ND-16-2452
10 CFR 50.90
10 CFR 52.63

Southern Nuclear Operating Company
Vogtle Electric Generating Plant Units 3 and 4
Request for License Amendment and Exemption:
Ventilation System Changes (LAR-16-030)

Enclosure 1

Ventilation System Changes

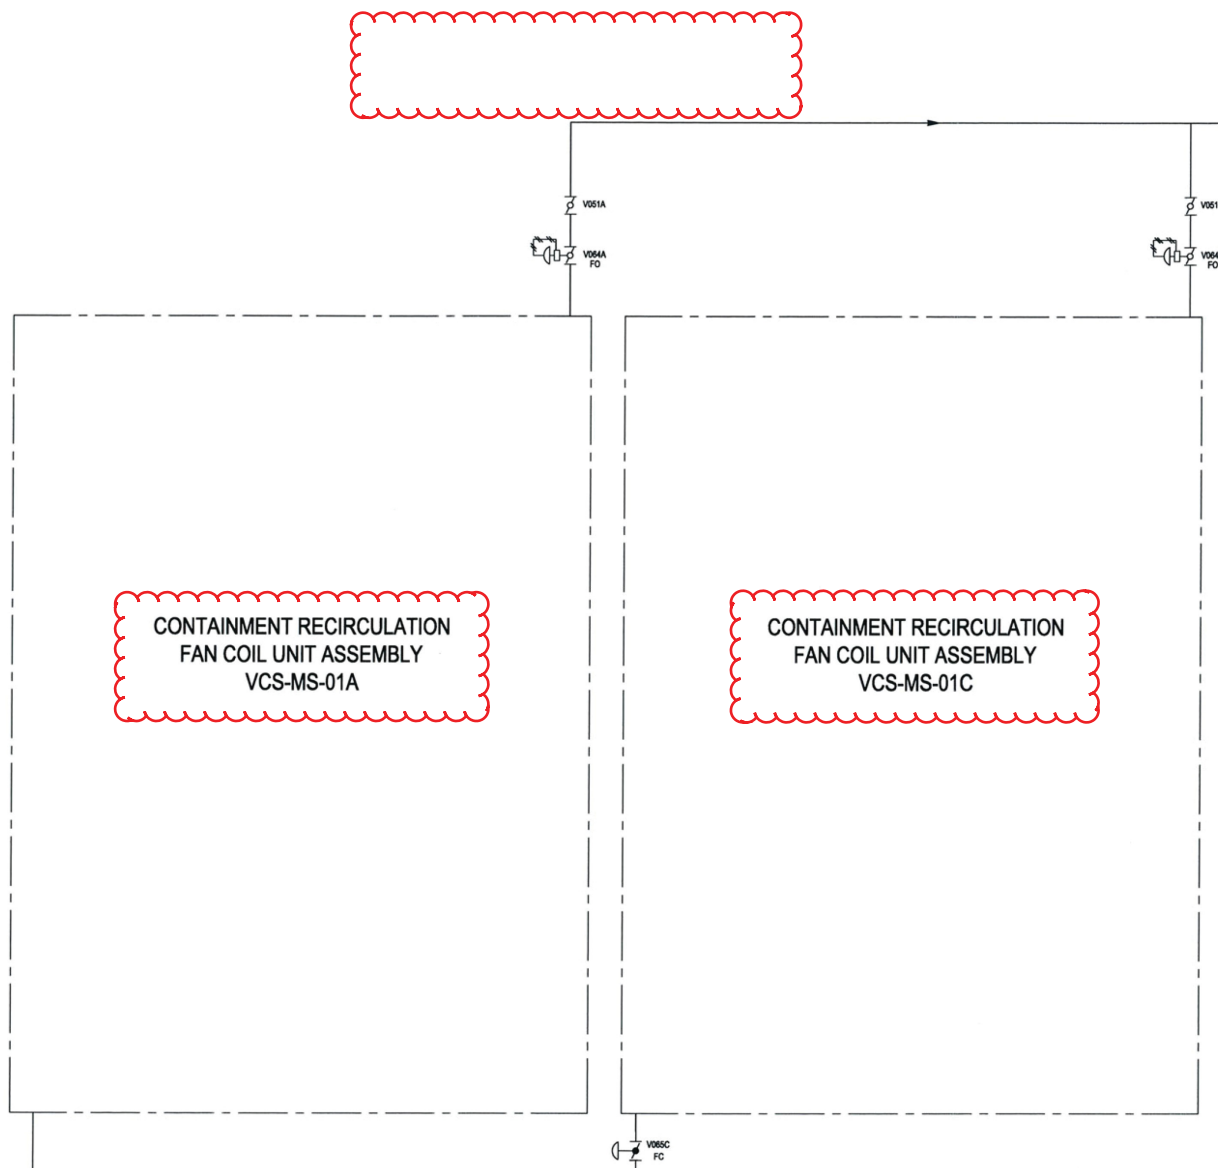
Revise Tier 1 information, as shown below:

3. **UFSAR Section 9.2, "Water Systems," Figure 9.2.7-1 (Sheet 3 of 4), "Simplified Central Chilled Water System Piping and Instrumentation Diagram (REF) VWS 003":**

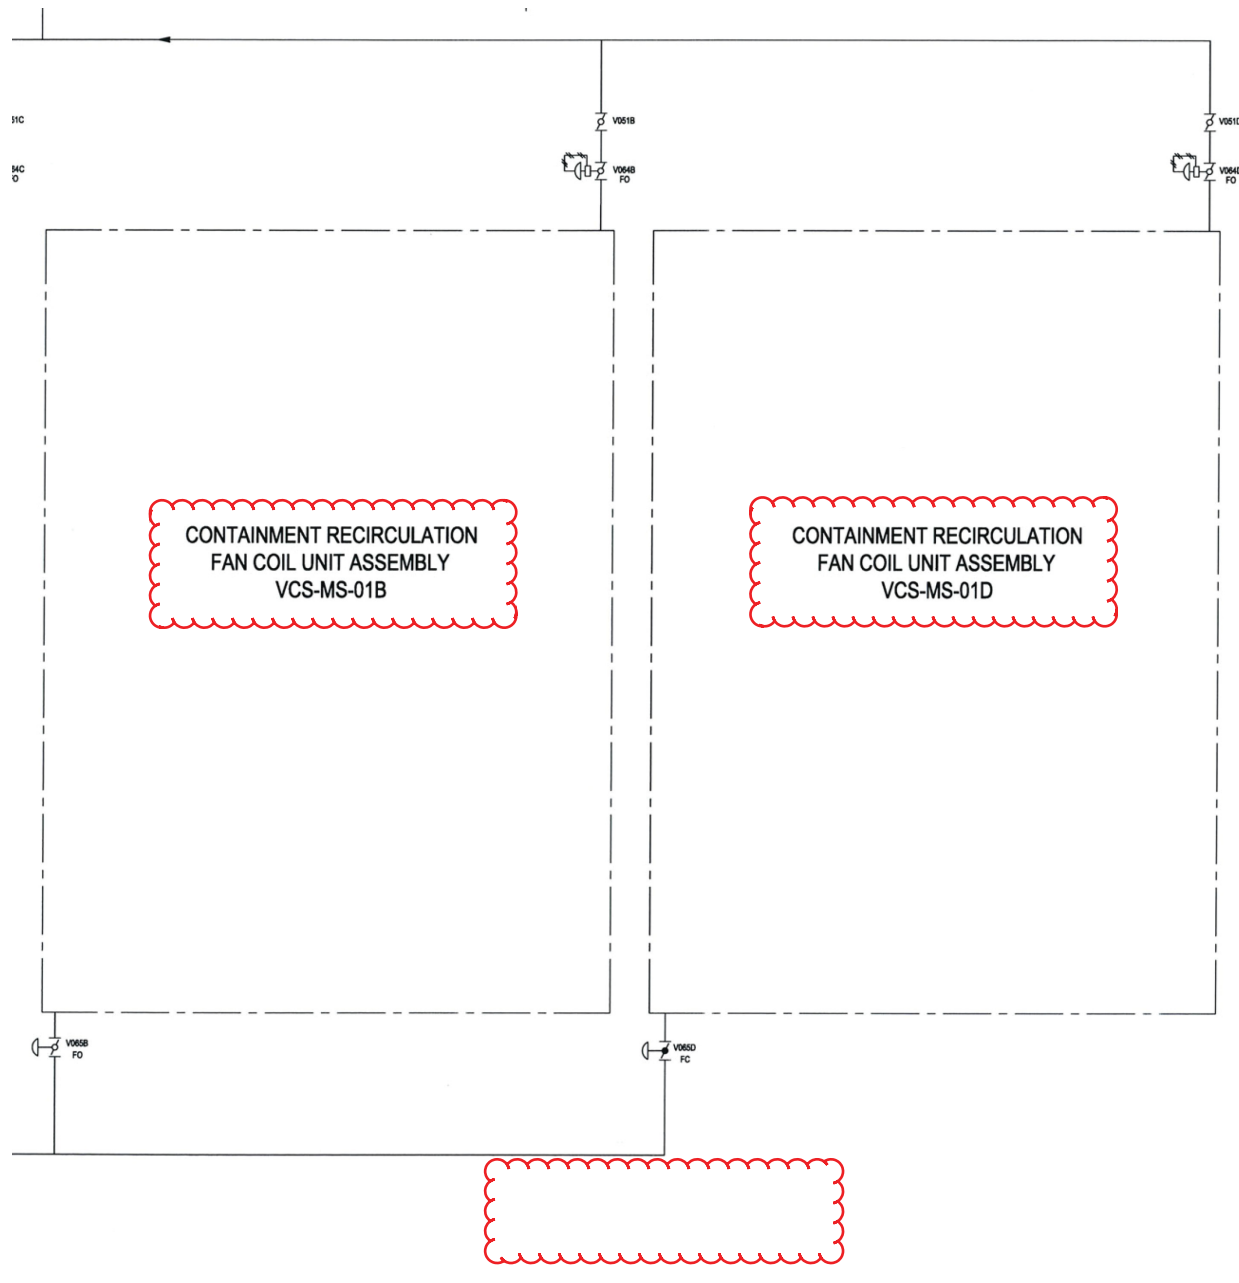
Revise Tier 2 information to add new containment recirculation fan coil unit assembly, VCS-MS-01C, to the units served by the central chilled water system (VWS) and alternately by the hot water heating system (VYS), as depicted below in the excerpt from the left side of the figure:

Revise Tier 2 information to add new containment recirculation fan coil unit assembly, VCS-MS-01D, to the units served by the VWS and alternately VYS, as depicted below in the excerpt from the right side of the figure:

8. **UFSAR Section 9.4, Figure 9.4.6-1, "Simplified Containment Recirculation Cooling System Piping and Instrumentation Diagram (REF) VCS 001":**

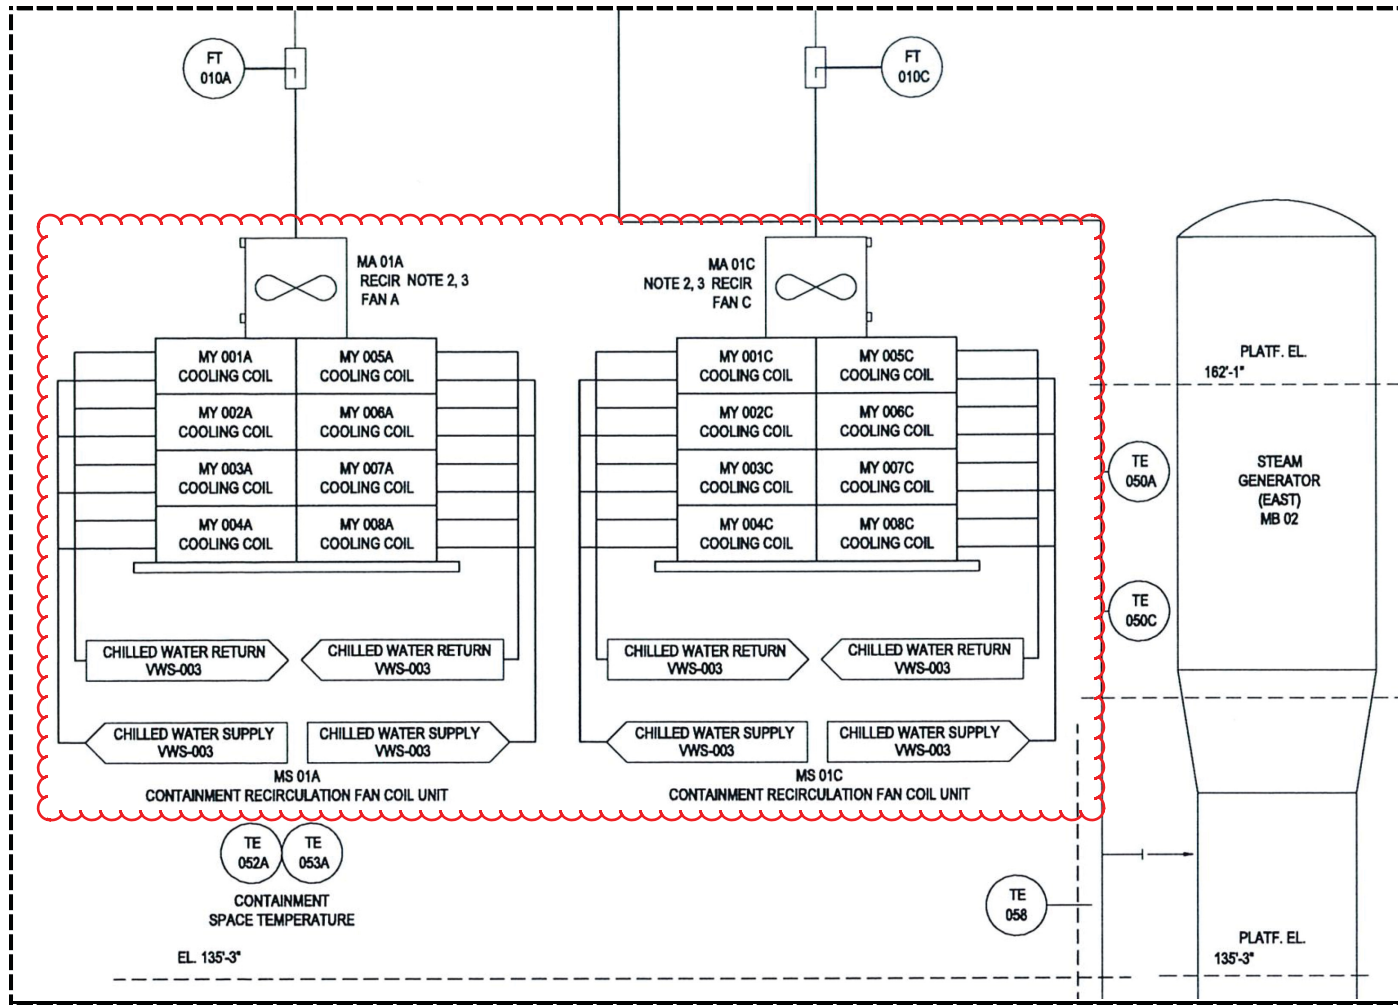
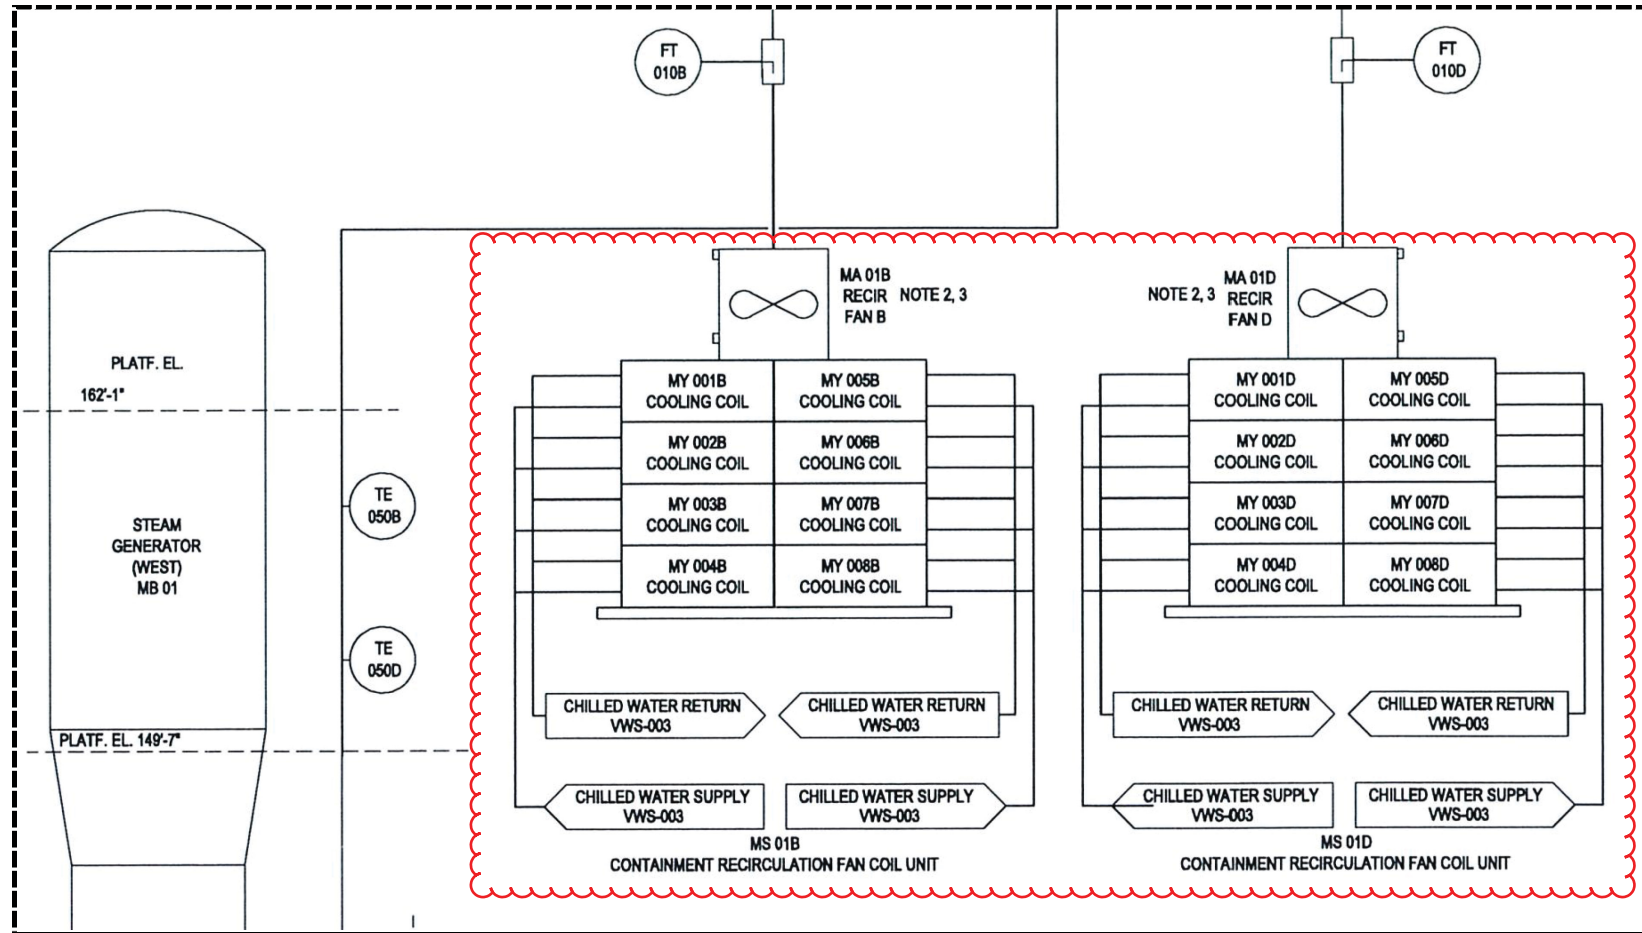
Revise Tier 2 information to change the number and configuration of the containment recirculation fan coil unit assemblies, as depicted below in the excerpt from the left side of the figure:

Revise Tier 2 information to change the number and configuration of the containment recirculation fan coil unit assemblies, as depicted below in the excerpt from the right side of the figure:
